**RE OPERATIONAL WORKS PERMIT (SUBDIVISION CIVIL WORKS) ON LAND DESCRIBED AS LOT
334 SP193431, LOCATED AT 84-160 CHRISTENSEN ROAD SOUTH, STAPYLTON**

Please find below our response to Councils Information Request dated 6th March 2019. Please be advised that we provide a full response to Councils Information Request and request the assessment of the application continue.

Description: Verge Profile Prepared By: KL Checked By: TJ Date: 26/03/19

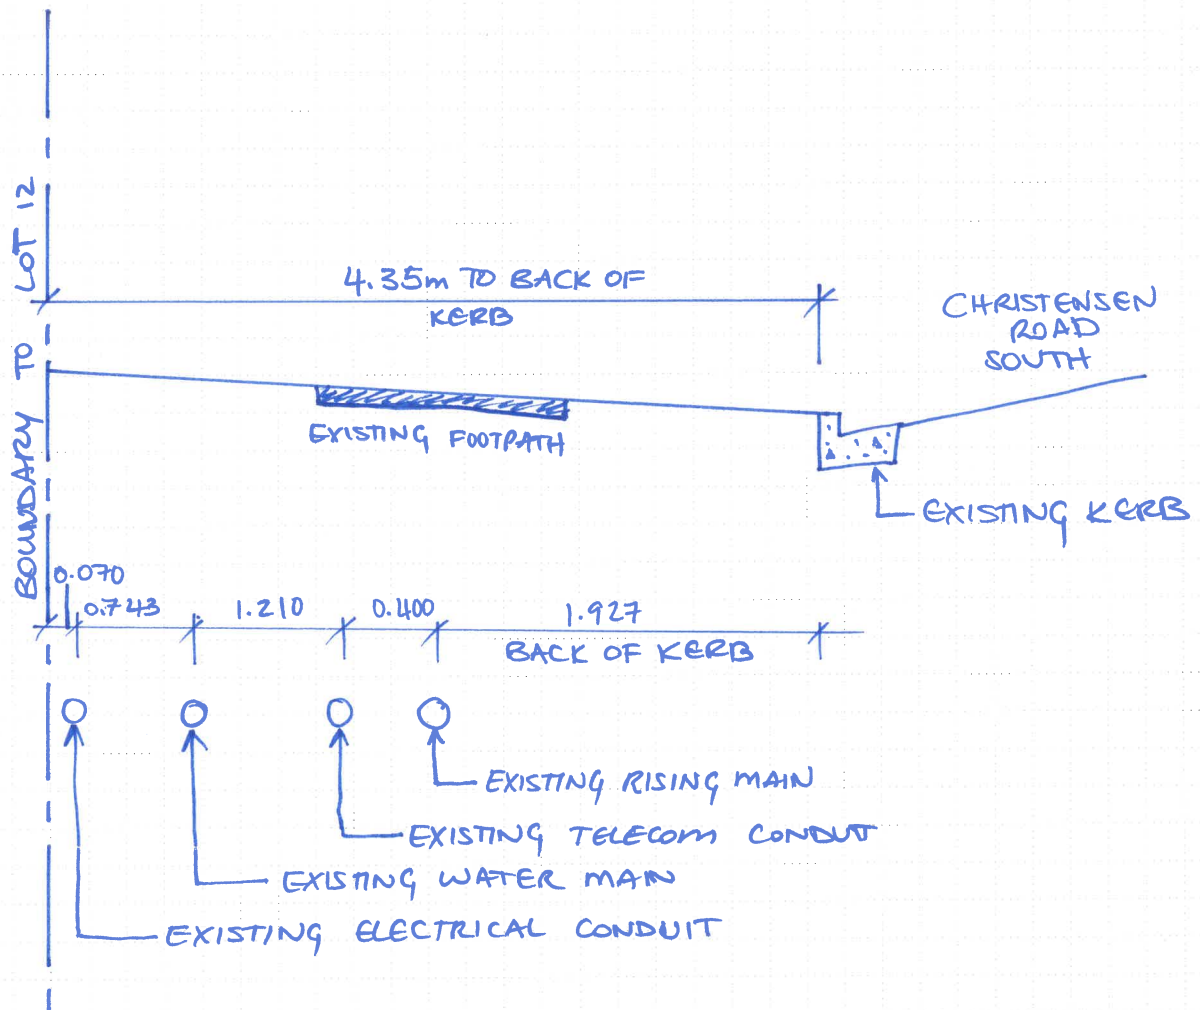
- g) Council does not support sewer mains to be installed under carriageways. Hence amend the design and move line 3 from under the carriageway to the northern verge of Christensen Road South. Ensure that the lid type on manhole 1/1 and 1/3 is amended accordingly to be non-trafficable.

Enclosed with this response is a sketch of the current verge profile outside Lot 12. There is not a lot of free area for services in this location which is why line 3 has been designed within the road reserve. Installing the proposed line 3 within the carriageway also ensures that all horizontal clearances to existing services have been met, in accordance with the WSA Code.

The alignment of the sewer line 3 was also designed such that the specified vertical clearances can be met to the existing Lot 12 stormwater connection (refer GCCC Application OPW201801421). If the line is installed

any closer to the verge, the correct vertical clearances cannot be achieved, with noting that the line between manholes 2/1 and EX/1 is existing.
